Design Evolution of Civic Square

This booklet demonstrates the design review process in Seattle. It shows the evolution of the design of Civic Square as a result of a series of six reviews by the city's Design Review Board and Design Commission.

Project
Civic Square, at 700 4th Ave., is the third and final component of the masterplan for the city's three block campus in downtown Seattle. The first two parts, City Hall and the Justice Center, were completed in 2002 and 2003.

6. Evolution of the Tower Form

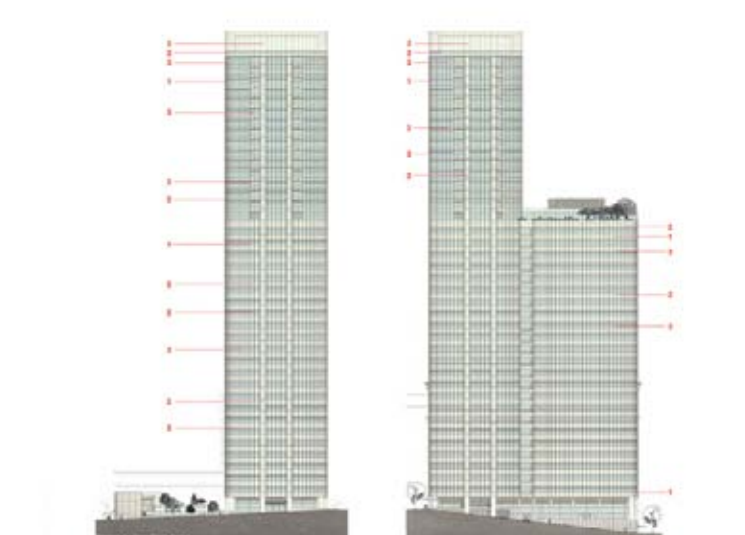
- » Approves the architect's idea to slide the residential block uphill to the east to emphasize the building's verticality at Fourth Ave. and Cherry St. closest to the Columbia Tower.
- » Recognizes that the architect had not completed the exploration of the building form for the residential block. Prefers to wait until the next meeting when the applicant presents two or three schemes with one identified as its preference.

- » Approves the form of the residential mass and its placement along Fourth Ave; however, provide a greater differentiation between the residential and office volumes.
- » The applicant's use of banding on the facades promotes an appearance of homogeneity marrying the masses too closely together. Produce different treatments of all the facades based on sustainable concepts.
- » Because the upper portions of the Cherry St. façade are quite long, they need more interesting things happening. These upper facades should become increasingly more interesting as one approaches a building.

- » Approves the vertical crease or modulation in the façade to differentiate two vertical shafts within the overall massing.
- » Provide greater differentiation of the building's skin in order to create a livelier and less monotonous façade.

- » Retain the different exterior expression between the residential portion of the tower and the office block.
- » All or portions of the first several office levels of the tower facing the plaza should respond to the plaza's presence.
- » Add balconies or some modification to the building skin or form to better marry the tower and the plaza. The tower's lower south façade should provide opportunity for the office tenants to interact with the ongoing activities on the plaza.

» The design of the building's final form defines a stepped tower differentiated by a distinct, vertical seam visually separating the two masses. This approach emphasizes the building's height, creates better proportions, addresses site conditions and responds to the buildings nearby.

7. Evolution of the Top

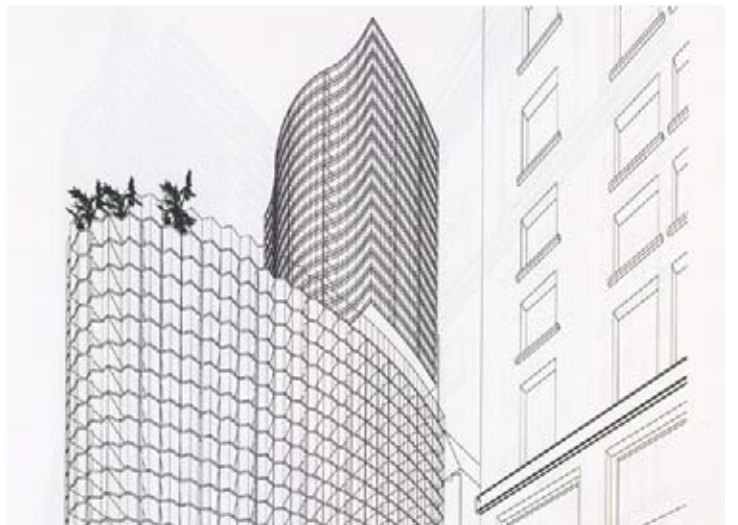
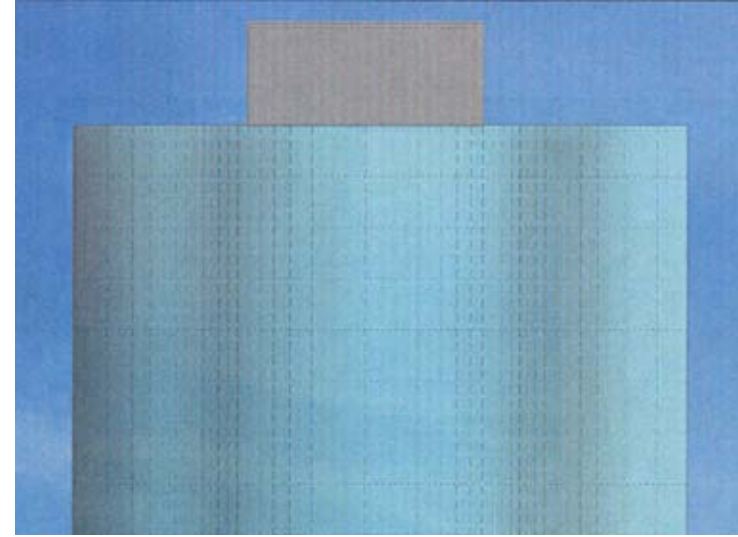
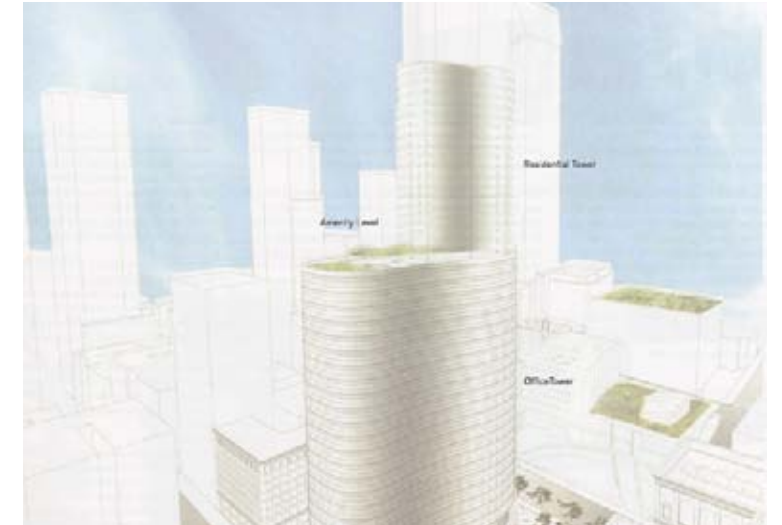
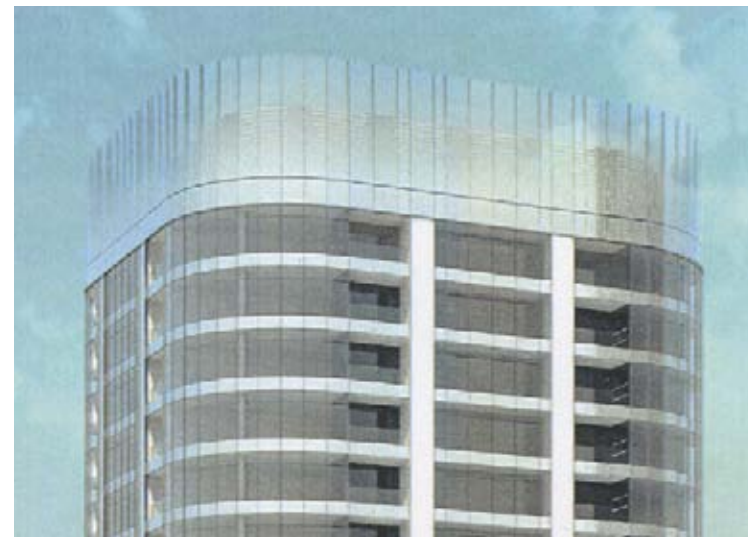
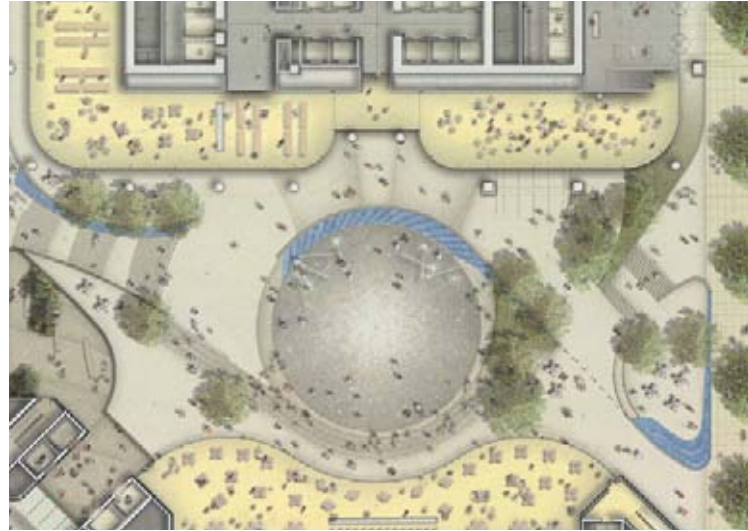
» The proposed tower will be highly visible from the west but particularly from the south where it lies on a diagonal between the Smith and the Columbia Towers, the city's oldest and tallest skyscrapers, respectively. Do not reinterpret or echo the Smith Tower. Although each of these structures will be iconic, they should not compete with one another.

» Approves sliding the residential block uphill to the east which would emphasize the building's verticality at Fourth Ave. and Cherry St. closest to the Columbia Tower.
 » Recognizing that the architect had not completed the exploration of the building form for the residential block, the Board did not comment upon the shape preferring to wait until the next review.

» The tower should possess a sense of conclusion. Both this proposal and the Smith Tower have a narrower tower rising above a base. The Board strongly encourages the architect to explore significant changes to the top.

- » Show a greater commitment to expressing the tower's verticality. Shaping the apex of the tower should enhance the sense of the vertical lift.
- » The concept of a box within a box (the mechanical penthouse surrounded by green walls within a glass enclosure) met with little enthusiasm.
- » Better express the technology of sustainability in the roof.
- » Design a more powerful image for the city skyline.

- » Refine the top of the tower with the intent of producing a more elegant presence on the Seattle skyline.

- » Approves the proposed roof design.

» The final design of the top terminates in a fritted glass parapet that screens mechanical equipment. The glass screen's shape mimics the form of the tower beneath it. The fritted glazing gradually becomes more transparent closer to the top. At night, the glass screen will be colorfully lit, creating a distinctive lantern.

» Glass screen wall whose fritted parapit tapers so it appears to disappear into the sky.
